Response to Anonymous Referee #3 comments on 'Topographic controls on landslide mobility: Modeling hurricane-induced landslide runout and debris-flow inundation in Puerto Rico' by Dianne L. Brien, Mark E. Reid, Collin Cronkite-Ratcliff, and Jonathan P. Perkins

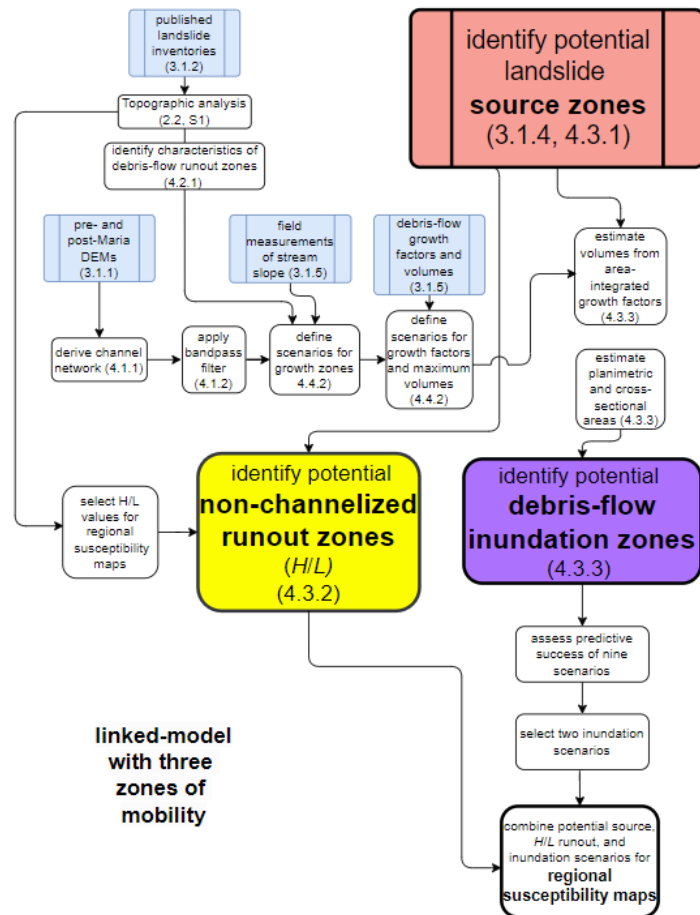
to read and understand the role of the topographic analysis. I also think that the content of Section 7.1 needs to be reconsidered. In this case, Figure 5 would be revise easier to understand, for example, the linked-model part is set as the main (routine) in the figure, and empirical parameters setting through topographic analysis was added as a sub-part (routine).

It was very difficult to understand the overall structure of the proposed model. I think that Figure 5 fulfills that role, but it difficult to understand. I made a few comments about this figure in comment 2.

Also, I think it is easier to understand if the relationships among the three models are the same in Figures 2 and 5. Also, it would be easier to understand if it indicated where in the text the methods for each part of the figure are written.

Thank you for these comments. Reviewer 2 also indicates that figure 2 did not serve the intended purpose. Figure 2 was intended as a primer, showing a simplified version of the coupled model approach, without the details provided in figure 5. The three colored boxes in figure 2 and figure 5 are equivalent and highlight the main components of the coupled model. The use of slightly different wording in the two figures may have made this connection difficult to see. We will either eliminate or revise figure 2.

Figure 5 has been significantly revised and now includes the associated section numbers. The flowchart details describing the topographic analysis have been moved to a supplement. The revised figure 5 now shows the connection to the topographic analysis as a more simplified, minor component, providing a primary emphasis on the coupled model. The main components of the coupled model are now further highlighted with larger boxes and font size. Here is the revised figure 5 flowchart :
